Illinois Tollway Standard Drawing Revisions

Section H		Roadway Lighting	
Standard	Modification Summary	Effective: 03-01-2024	
H1-12	LIGHT STANDARD FOUNDATION		
Sheet 1	Revised the bolt projection dimension from 3-1/3" to 2-1/2". Added detailed notes to Note 1 to address the grading changes surrounding the light standard foundation.

LIGHT STANDARD FOUNDATION DETAILS - ADJACENT TO GUARDRAIL
(GROUND MOUNTED UNITS)

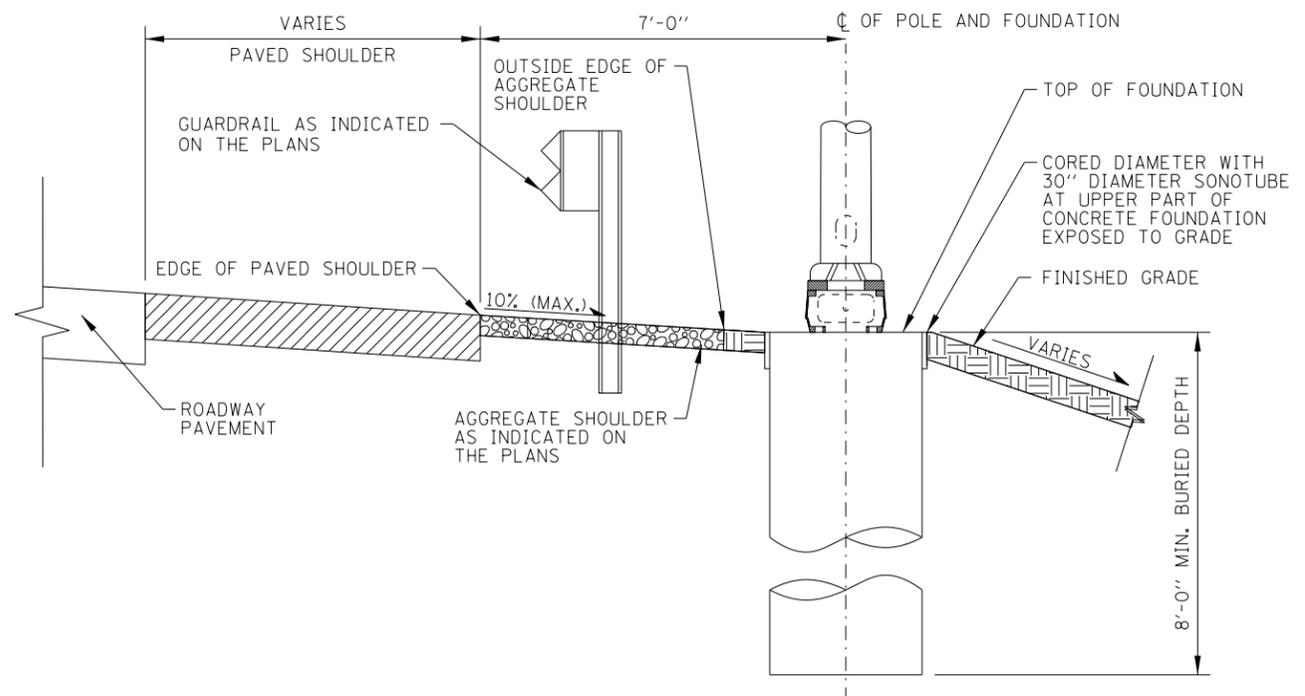
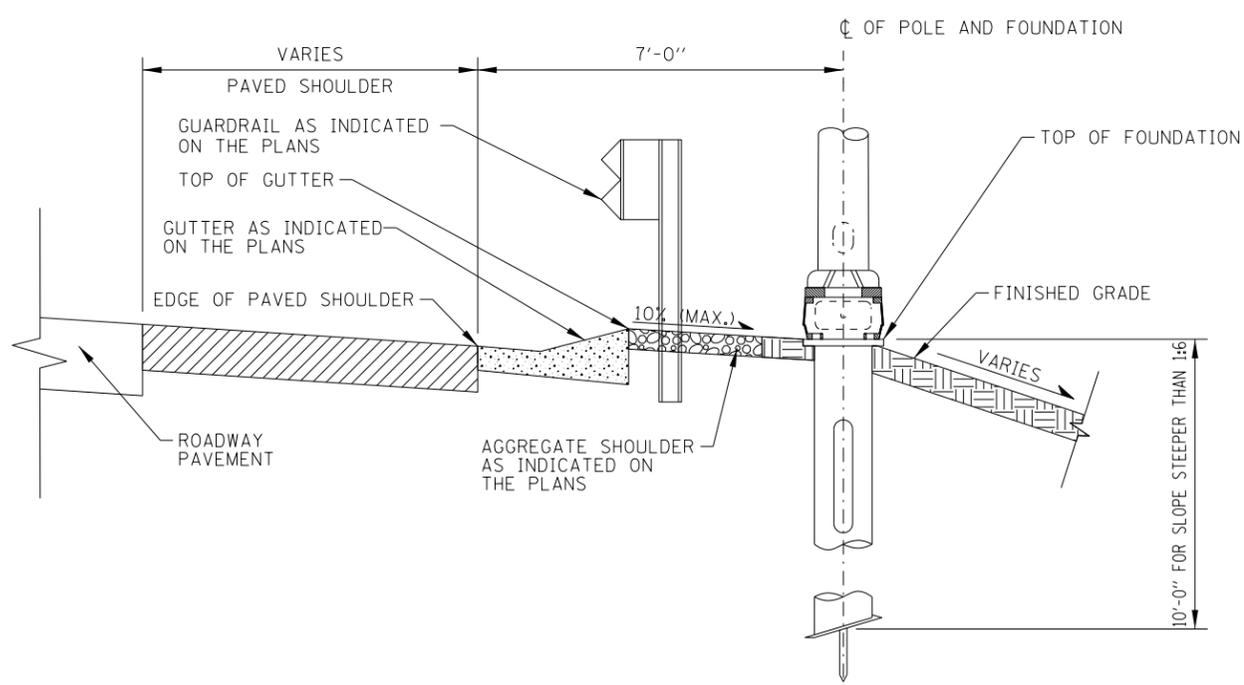
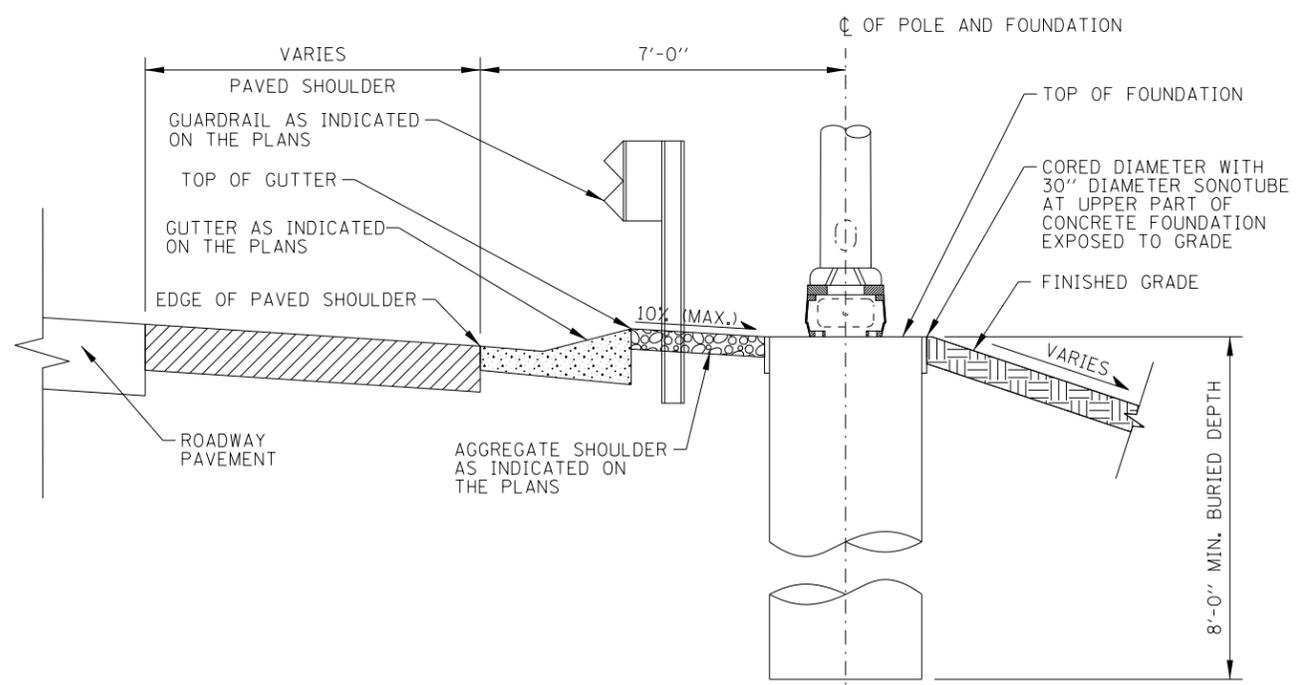
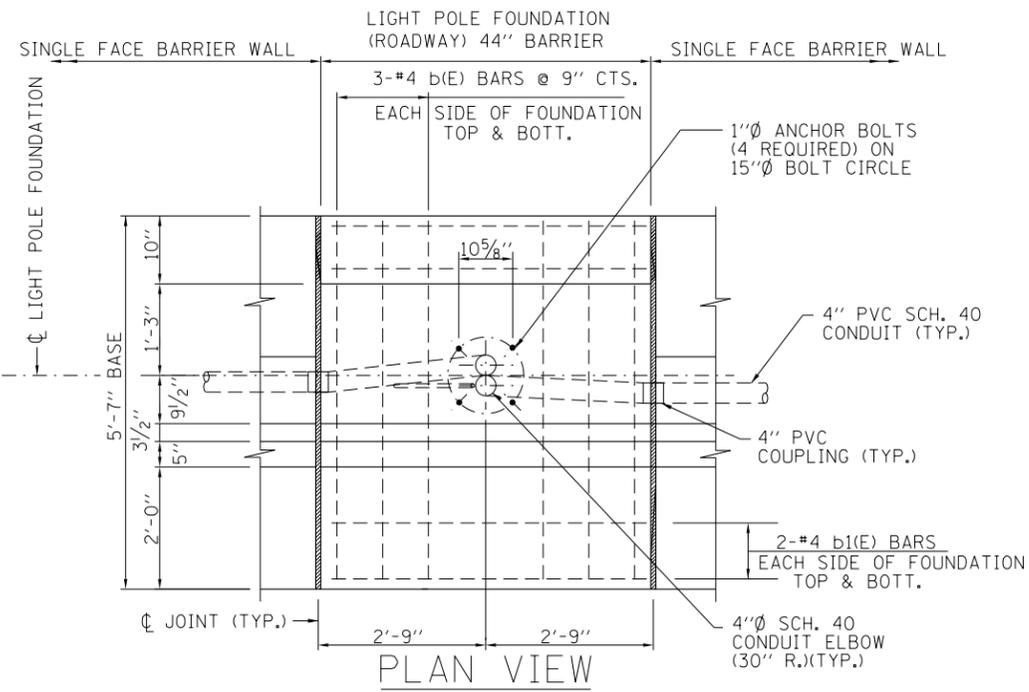
Sheet 9	Revised grading details to account for slope adjustments.		
Sheet 10	Revised the class DS concrete Class SI concrete to be shown below the conduit. Removed the dimension of the anchor bolt from the elevation view.		
H2-10	LIGHT STANDARD DETAILS

CONDUIT EMBEDDED IN BRIDGE PARAPET WALLS
(INTEGRAL/SEMI-INTEGRAL ABUTMENT WITH PARAPET ON APPROACH PAVEMENT)

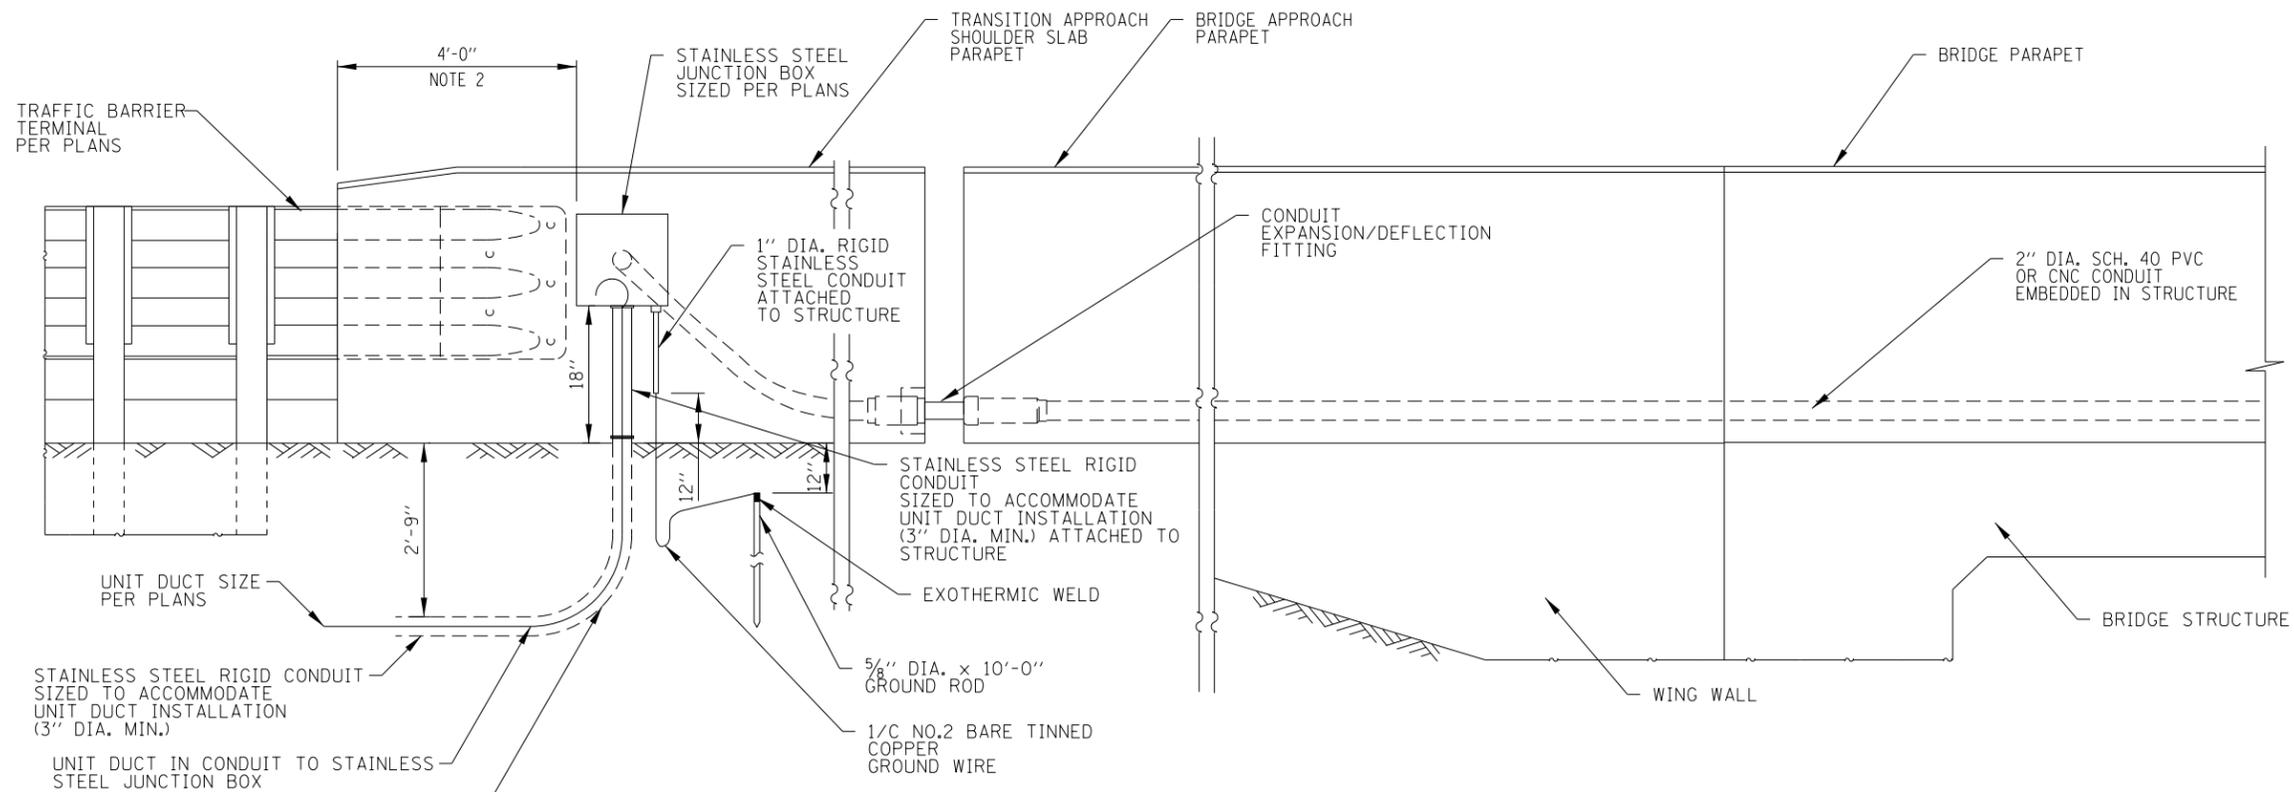
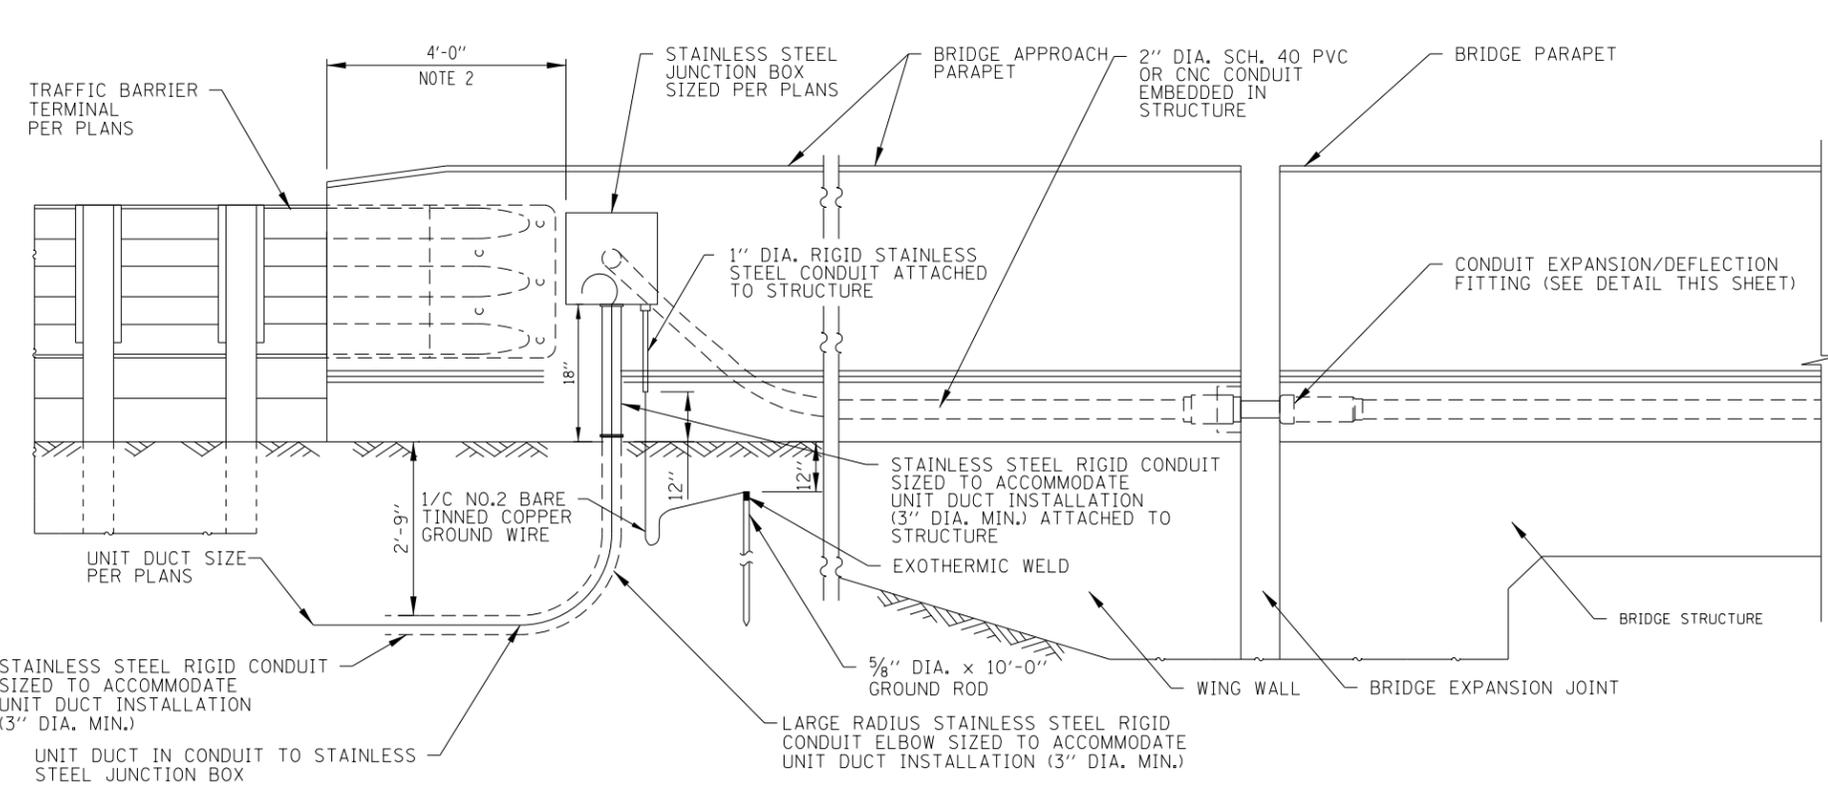
Sheet 1	Removed the dimension of the anchor bolt from the Section A-A view.		
Sheet 2	Added the transition slab to the Integral/Semi-Integral abutment with parapet on approach parapet detail.

SECTION A-A

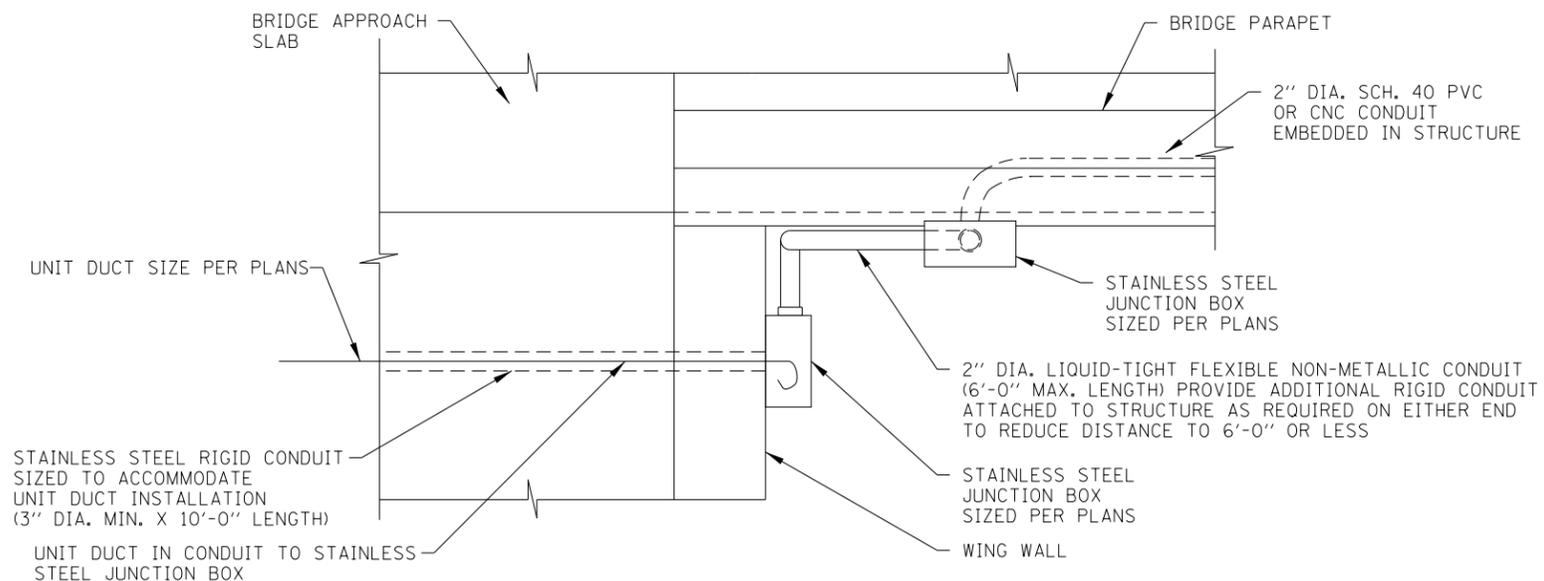
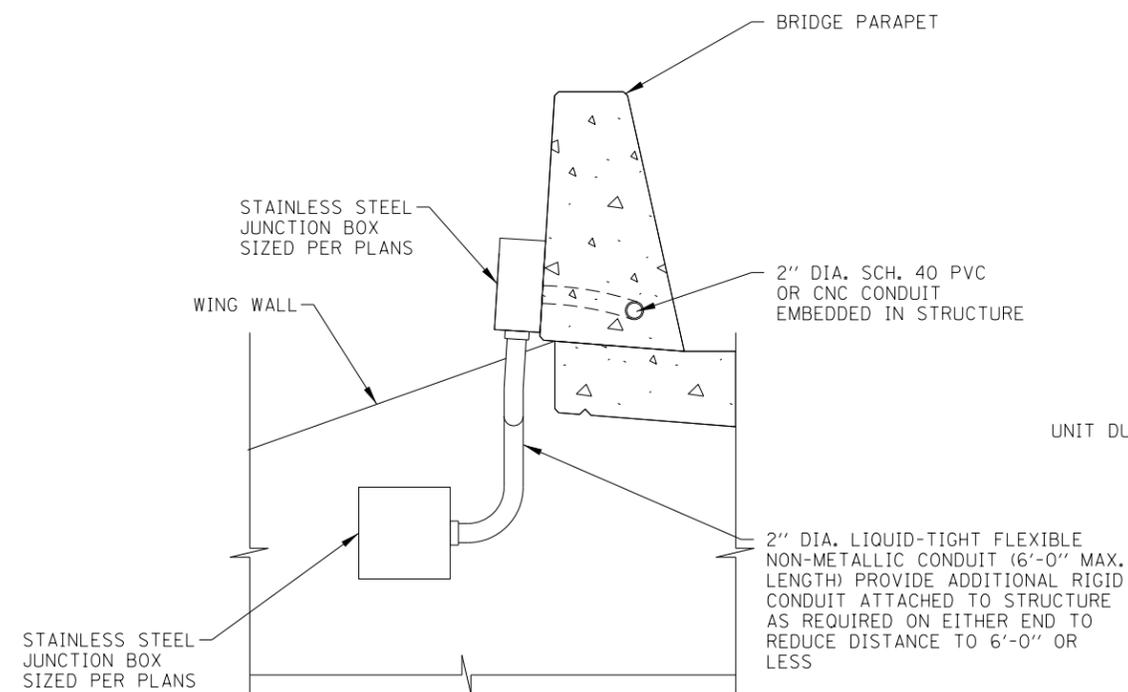
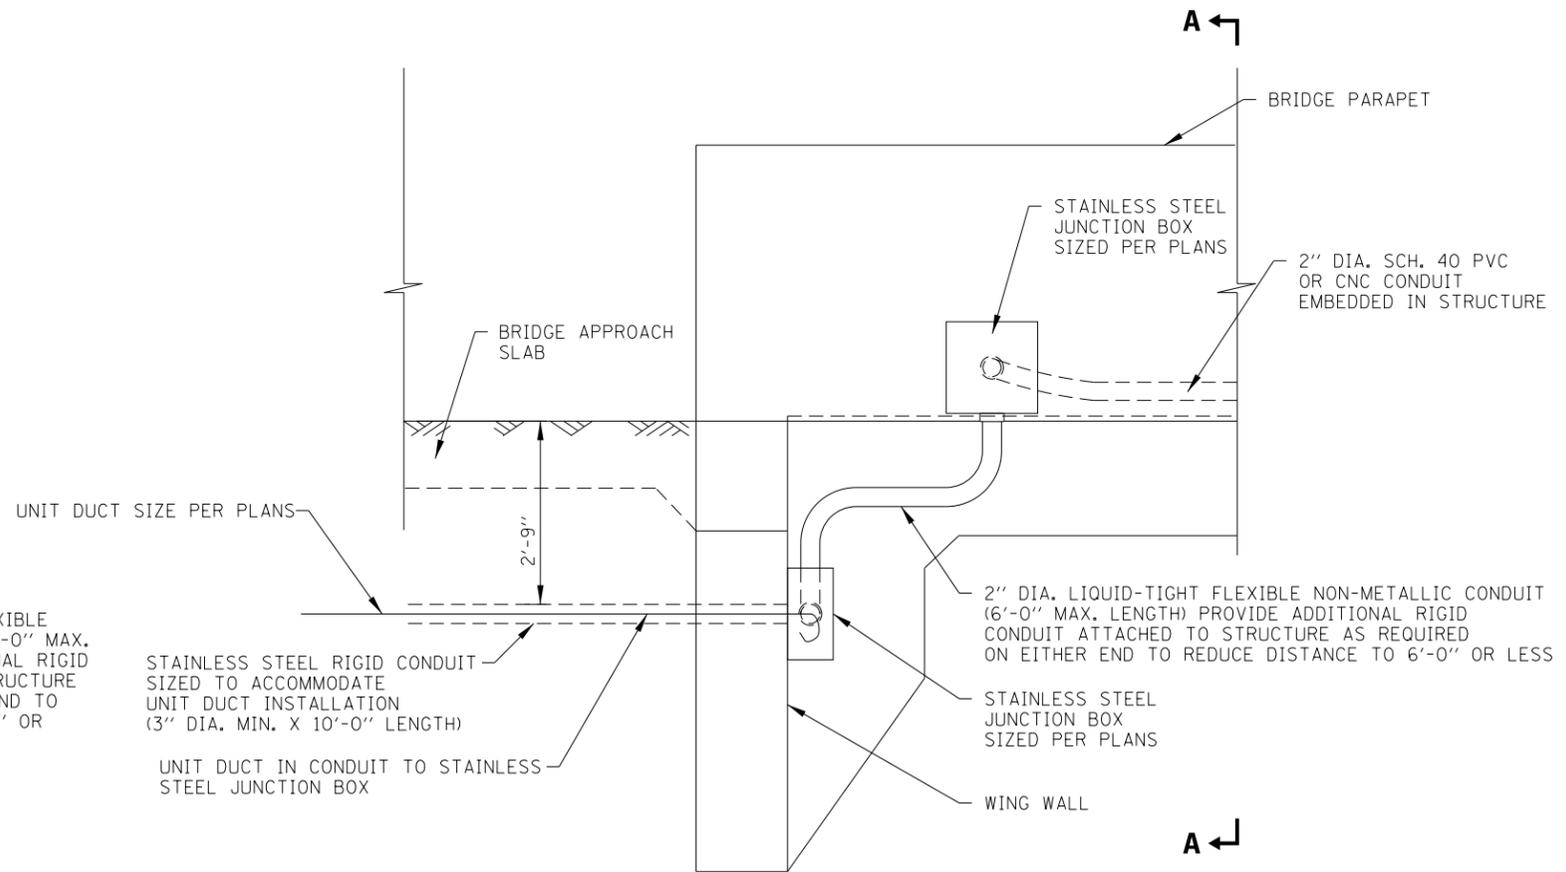
Sheet 3	Revised callouts for Section A-A view.		
Sheet 4	Revised callouts to the elevation view.		
H4-06	HEAVY-DUTY HANDHOLE AND BURIED WIRING DETAILS		
	Added Note 7 and callout to Note 7 at the handhole elevation view.		
H10-05	BRIDGE MOUNT SIGN LIGHTING DETAILS

HEAVY-DUTY HANDHOLE AND BURIED WIRING DETAILS

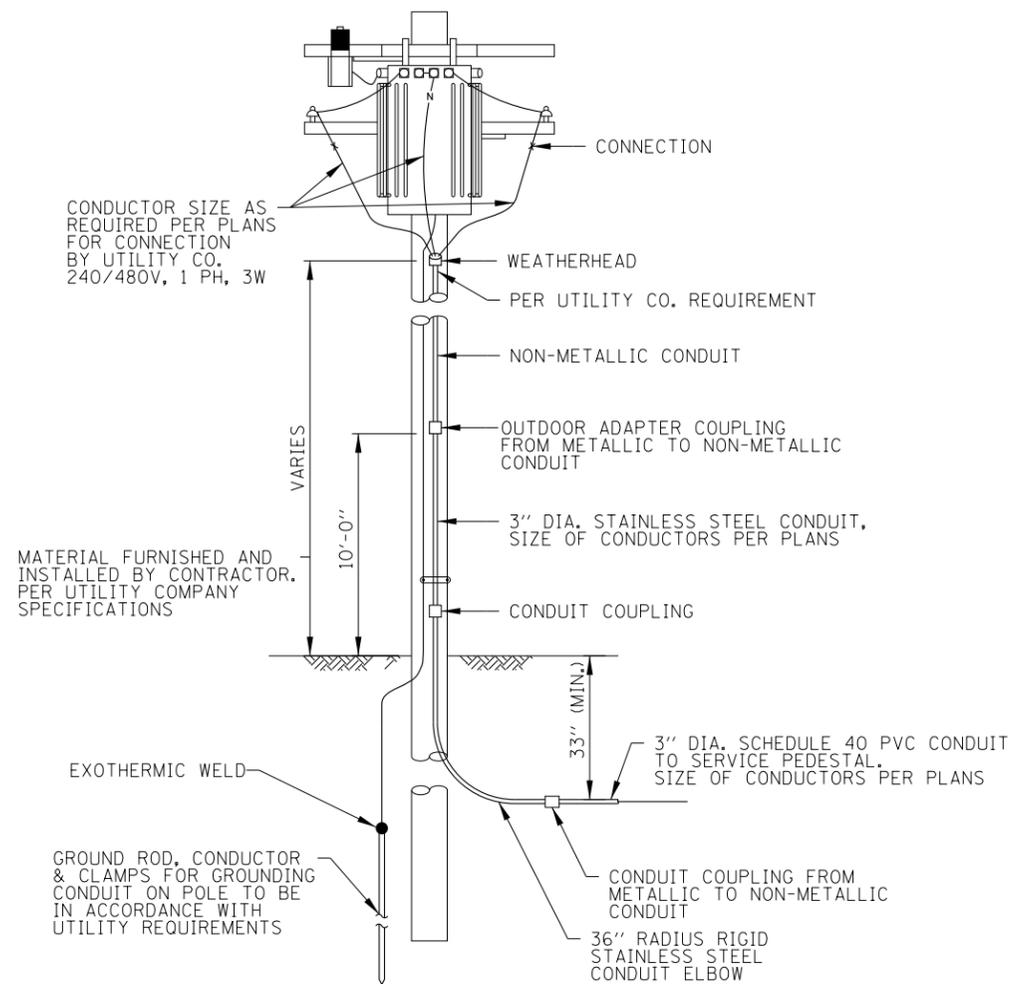
DATE	REVISIONS
3-01-2024	REVISED TO REFERENCE DETAILS FOR BURIED WIRING. ADDED NOTE 7
3-01-2021	REMOVED SAND FROM CONDUIT TRENCH. GROUND ROD SHOWN IN ELEV. VIEW.
3-31-2017	REVISED NOTES. REMOVED GROUND ROD FROM DETAIL.
